**April 9, 2013  
Medway Planning and Economic Development Board  
155 Village Street  
Medway, MA 02053**

**PUBLIC HEARING CONTINUATION - Tri Valley Commons Site Plan – 72 Main St – Calarese Development:**

**Re: Tri Valley Commons  
72 Main Street  
Site Plan Review  
Medway, Massachusetts**

**From:** Dan Hooper [dan.hooper@verizon.net]  
**Sent:** Tuesday, April 09, 2013 1:36 PM  
**To:** Susan Affleck-Childs  
**Subject:** Rod's renderings

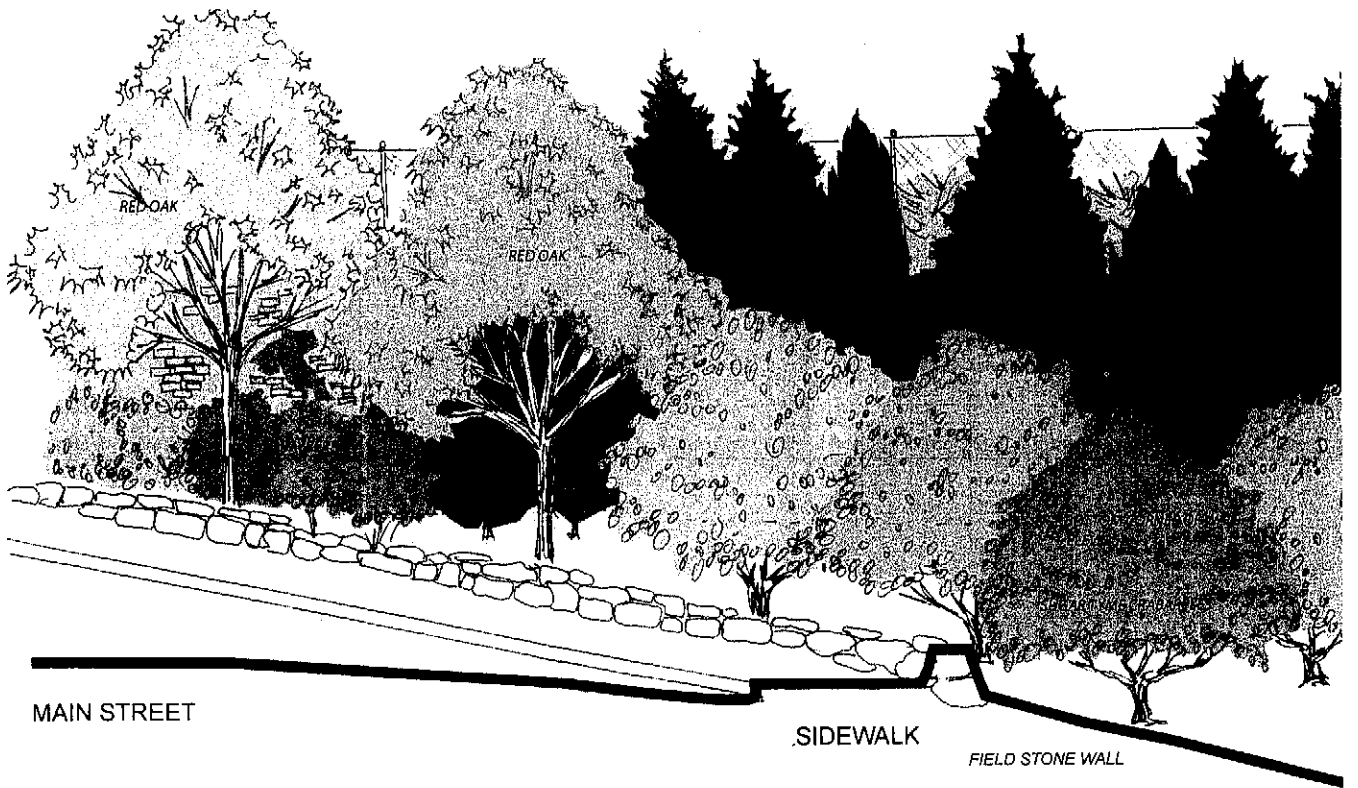
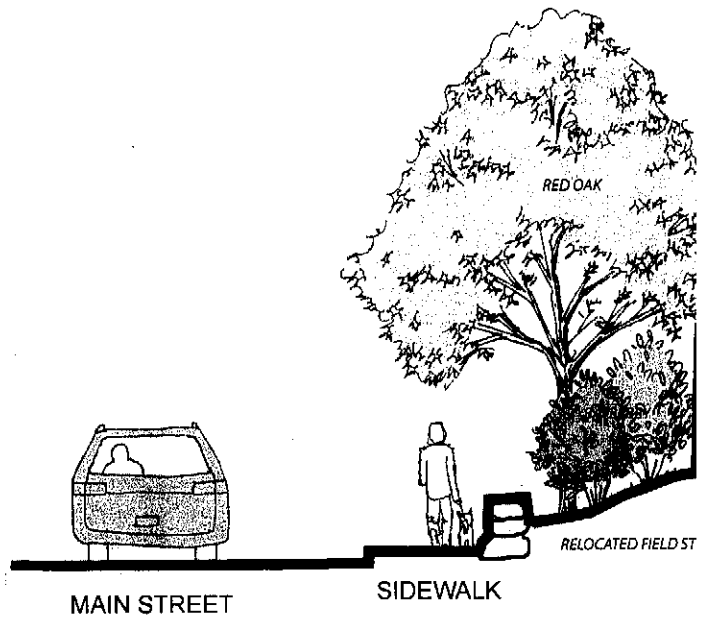
Dan Hooper communicated that the specifications for landscaping (*as noted on the site plan*) do not coincide with what is depicted on the landscape architect’s rendering. He wanted to make sure that these discrepancies are called out to the Board. He stated he understands that the Board may not wish to discuss the images he submitted late this afternoon. But there are discrepancies and the Board should make its decisions based on accurate drawings.

Dan Hooper also noted it will be difficult to find 25-30 ft. evergreen trees to plant. That size tree is what is being shown on that plan. He expressed his hope that when the Board continues to discuss this it will make sure it is evaluating reality versus a rendering of what might be.

Here are some images that will articulate the wall and surrounds along Main St. as proposed by Tri Valley to the DRC last week. From what I see of the rendering the PEDB rec'd yesterday and corresponding plan and spec (dated April 3), this illustration is accurate, except perhaps for a few trees and a variation on the plant-type atop the wall (to a smaller evergreen plant).

ELEVATION B - B' PLANTING AT FRONT CORNER OF WALL

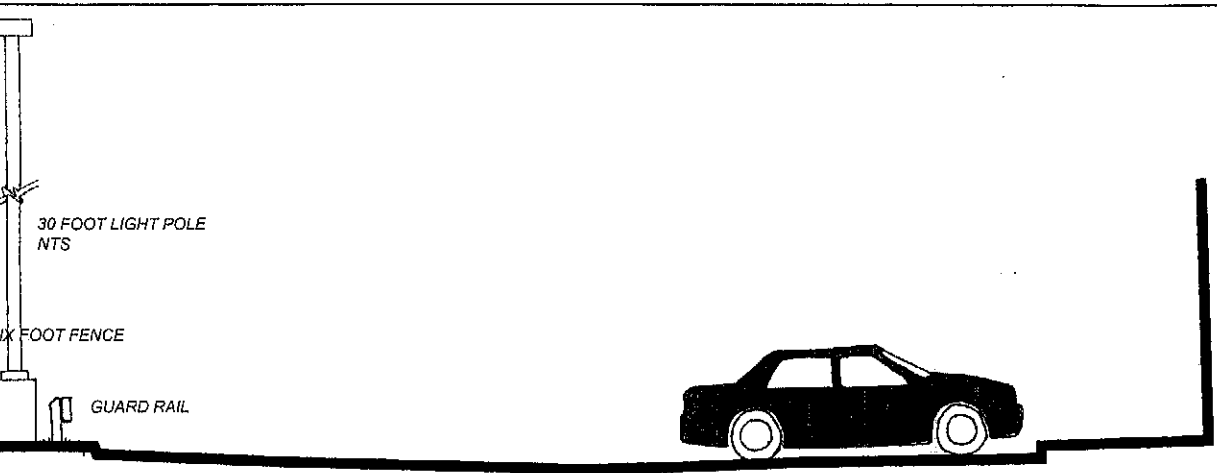
Member Walsh stated that “that” was not an elevation. (*She was referring to the April 9, 2013 section and elevation drawing from Green International*). It is not an elevation of the entire wall. It is an elevation of only the corner (*closest to Route 109*).

Member Spiller-Walsh indicated that the applicant has only provided something to show that corner of the wall with the trees on it, which is not consistent with the recently revised site plan in terms of scale.
